**Staff Analysis of a Proposed Amendment to the
Dane County Water Quality Plan, Revising the Environmental Corridors
of the Waunakee Urban Service Area
in the Village of Waunakee**

Stormwater Management

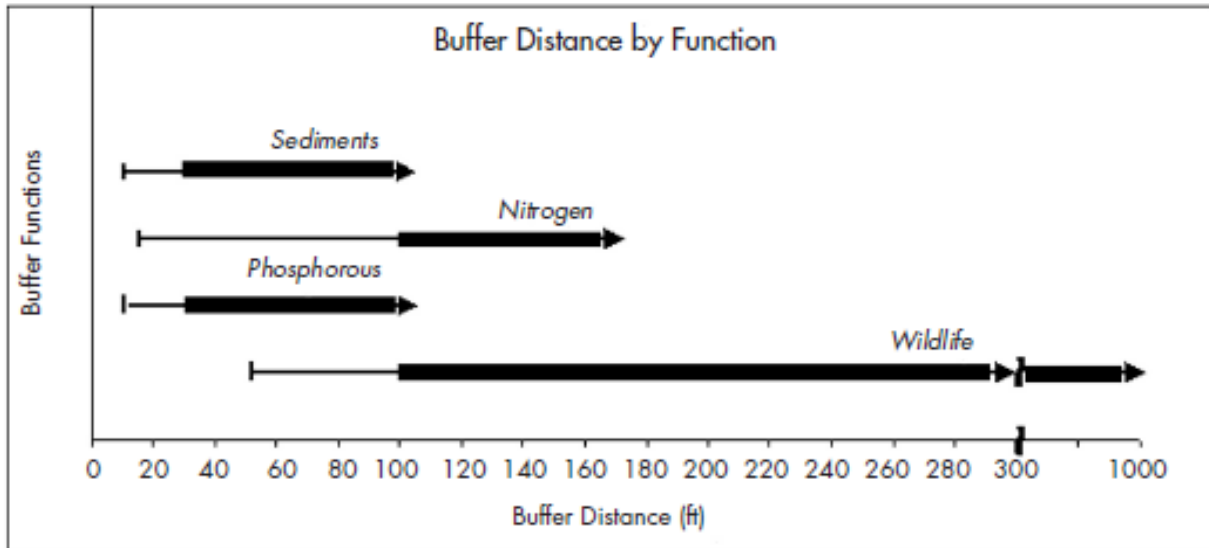
The concept stormwater management plan meets or exceeds the stormwater management requirements in Village of Waunakee (Chapter 109) and Dane County (Chapter 14) ordinances.
